3.11 KONTROLL AV PRODUKSJONSTEGNINGER LAFT

Dato:	15.6.15	Prosjektnavn:	Kjetil Solberg
Tegning:	Produksjonstegninger		
Tegner:	HSK	Nivå:	Sjekk 1

B-1

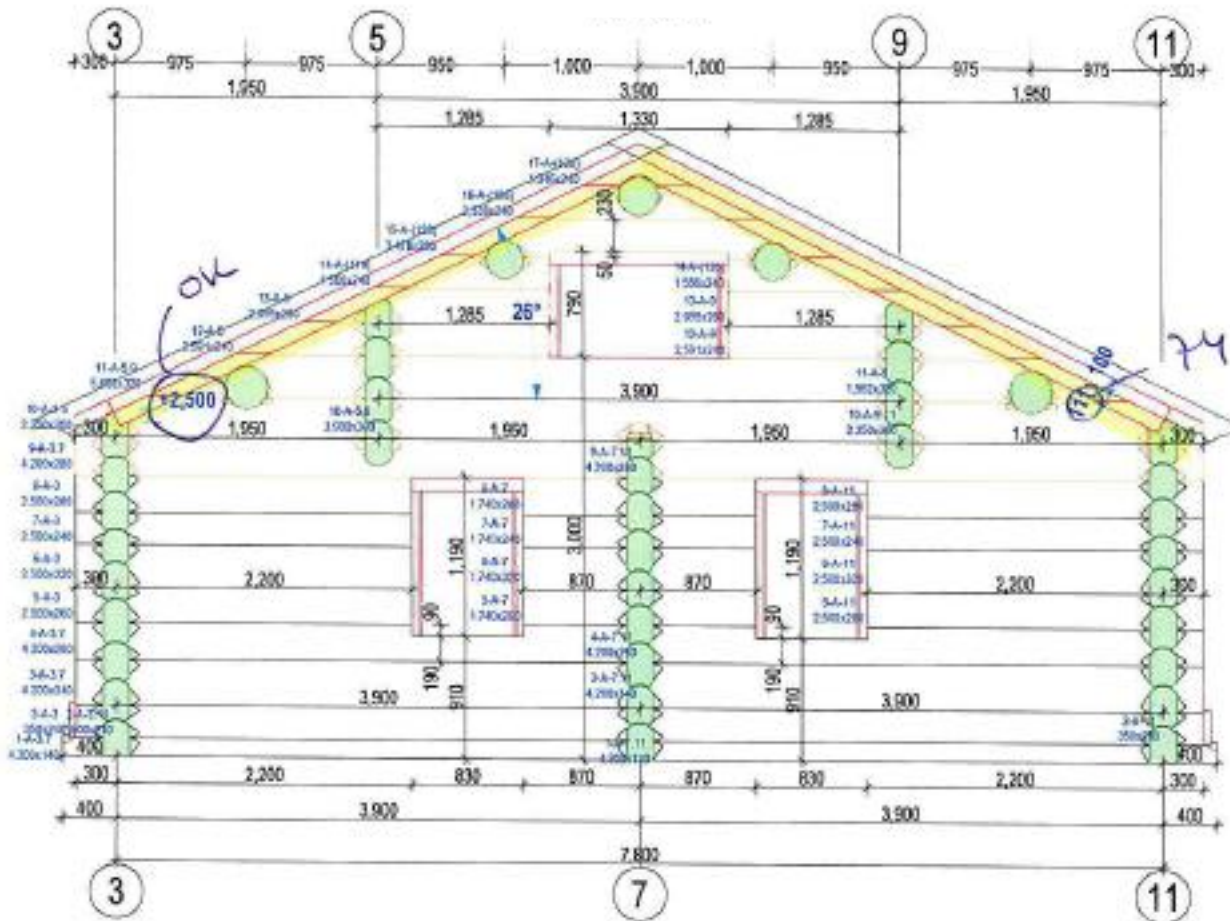
We recommend to put, between windows, legs who not shorter than 600 mm. (crash danger)

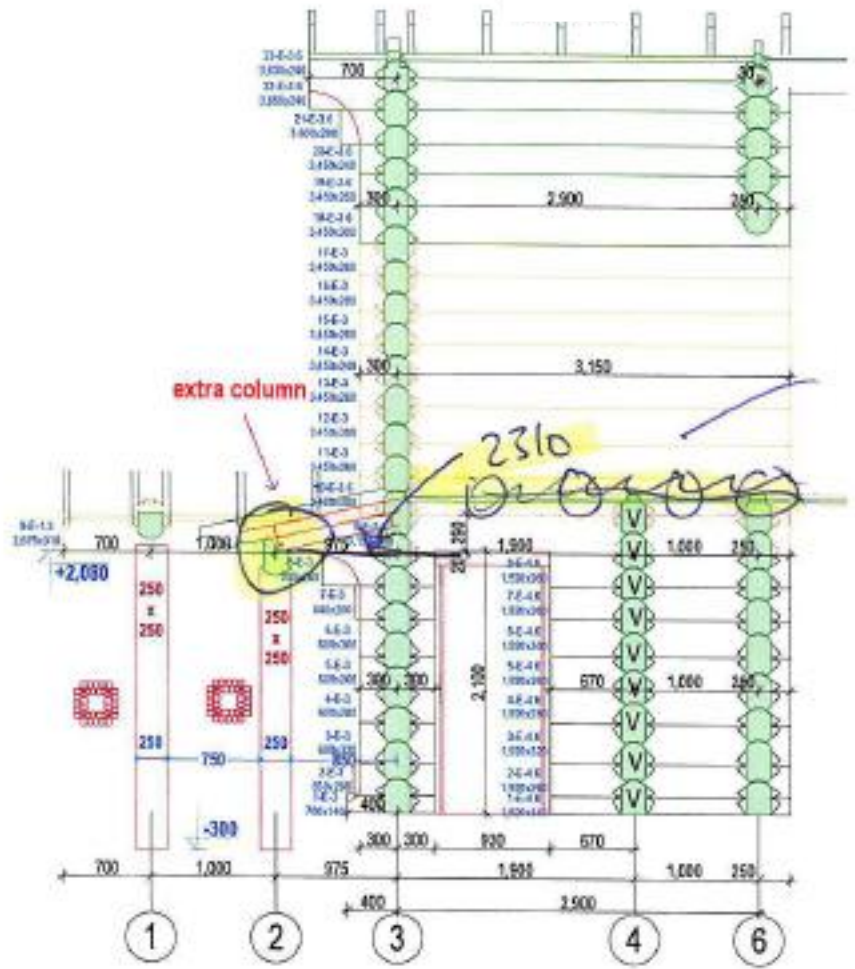
approx 2200

sorry
No floor
beams
in this
direction

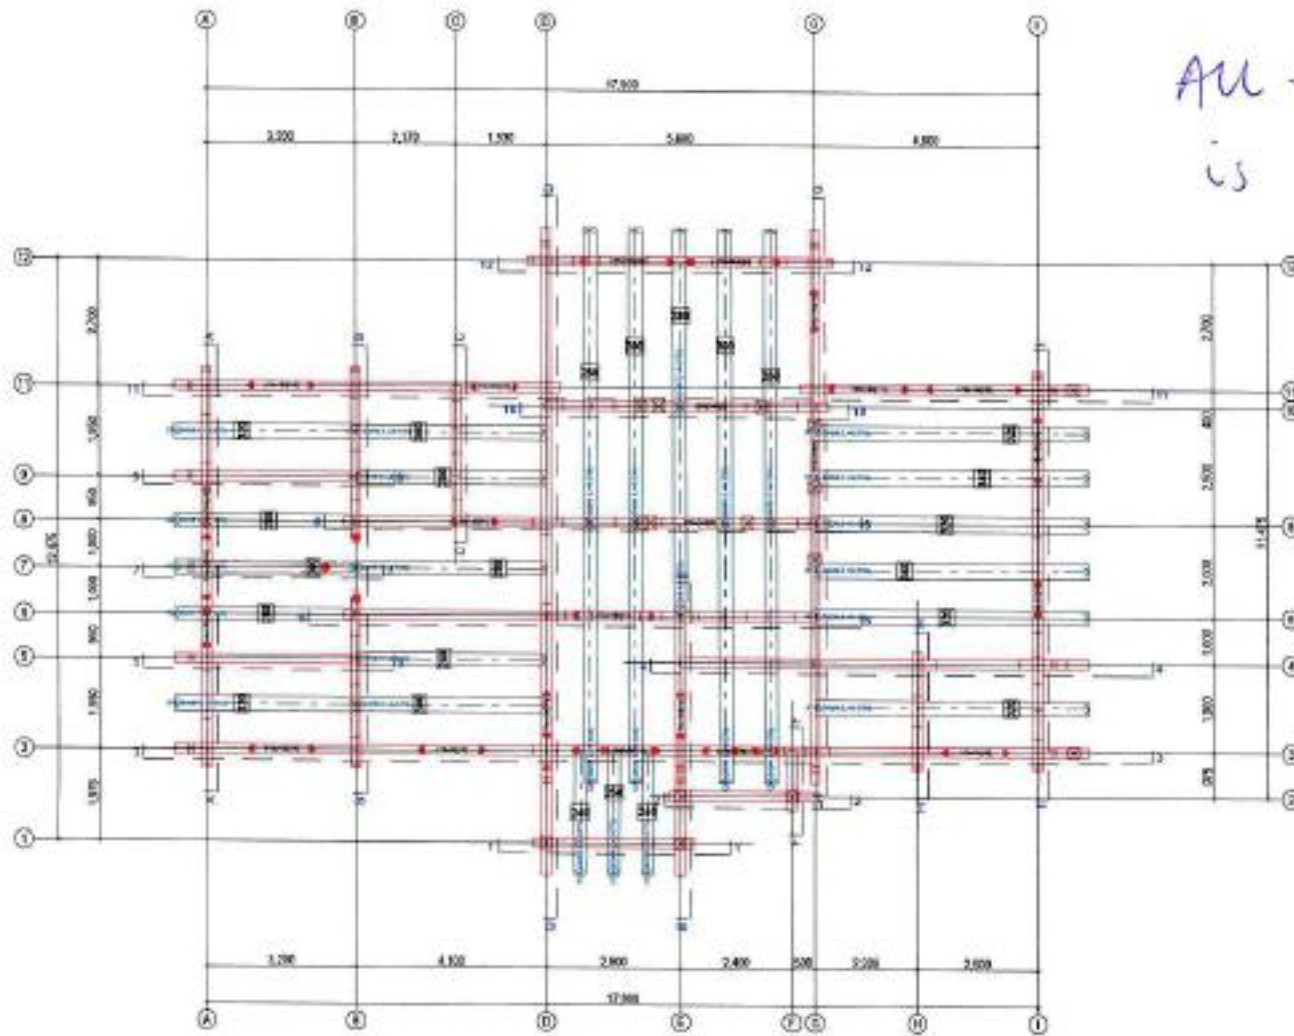
SORRY
 This is wrong
 no beam in
 this direction

All values size
is OK

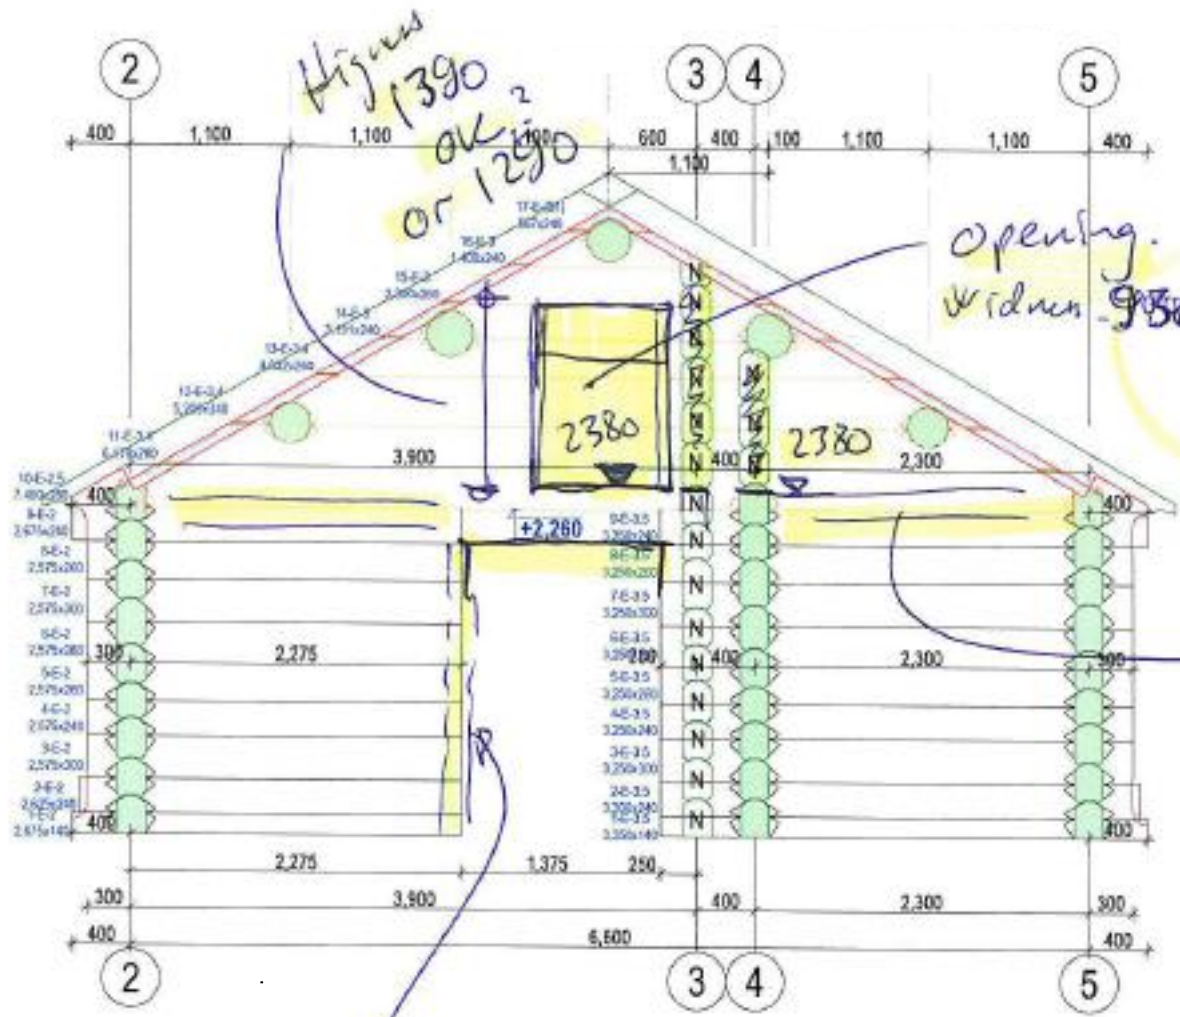
Highness
1390
or 1290

Opening
width 930

Opening hems.

We will
make floor
in Norway.
No delivery
of logbeams for
floor.

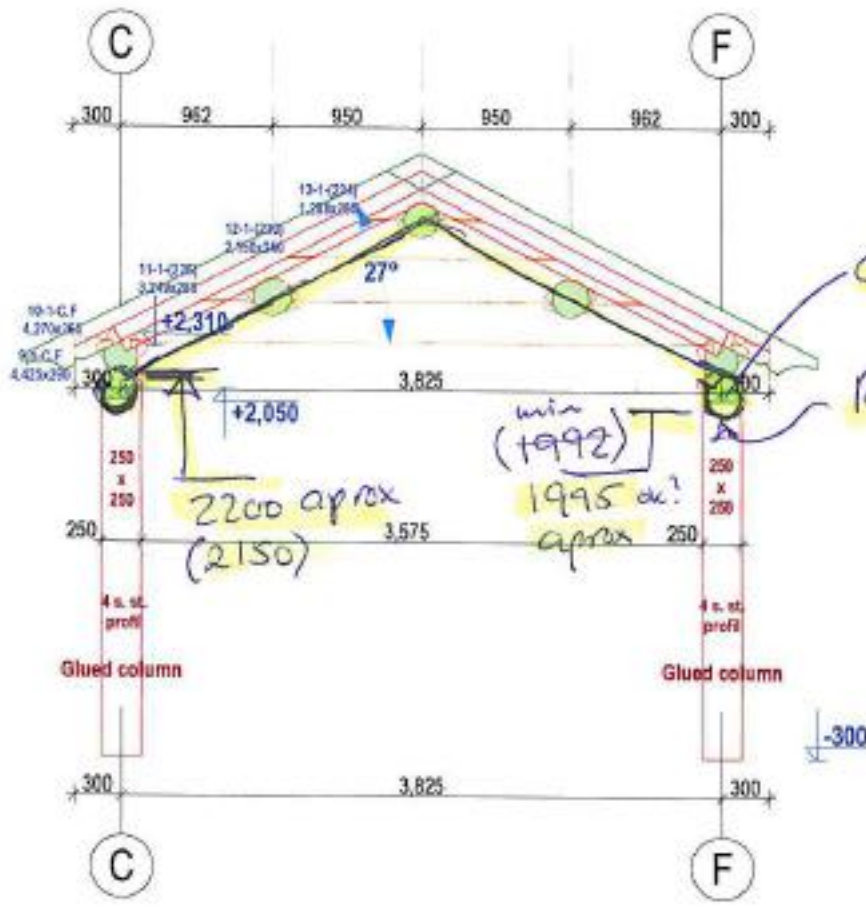
Hens. We will make floor for hens in Norway.

Min ϕ 320

only one log.

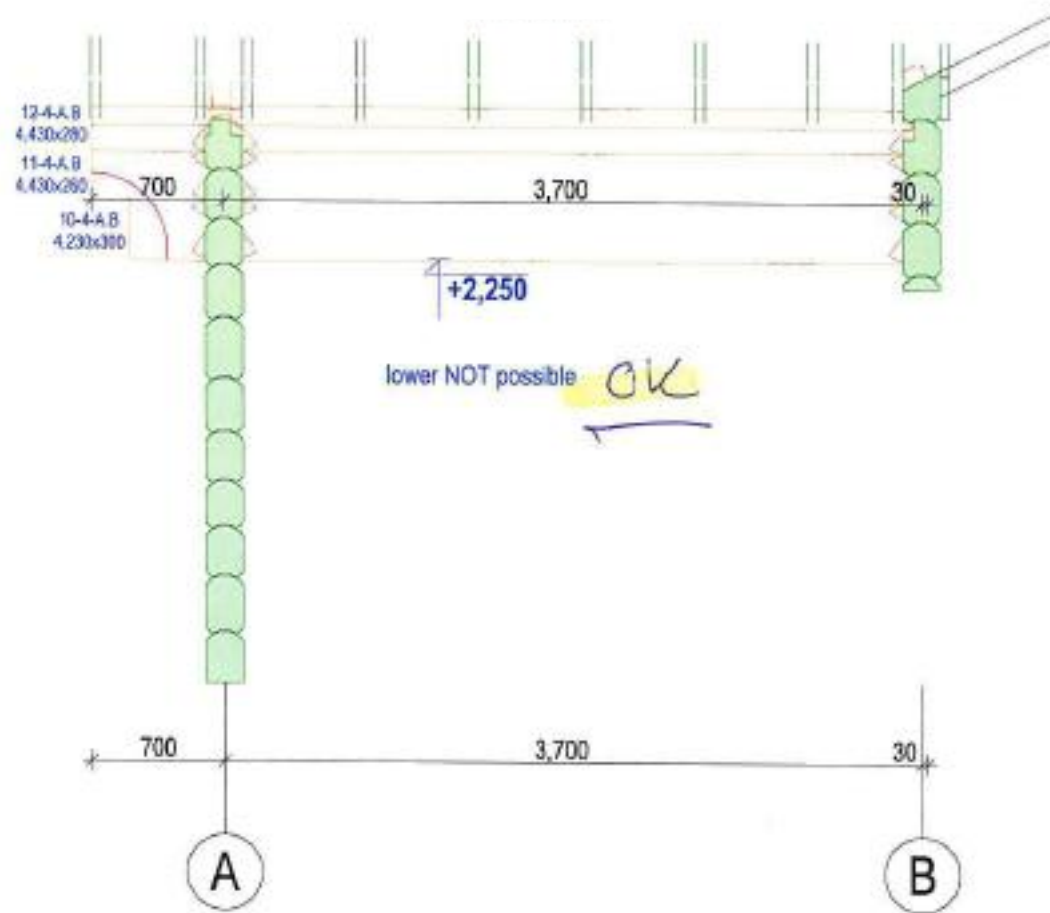
Wall 7 will be same line as wall 8

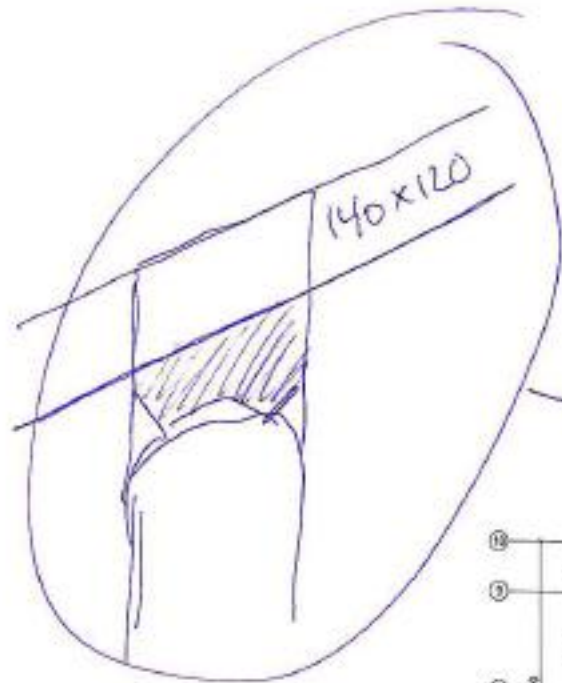
No hole true for
spar 140x120
Stop in wall.
if its necessary
we cut opening
in Norway.
Deliver spar
long enough
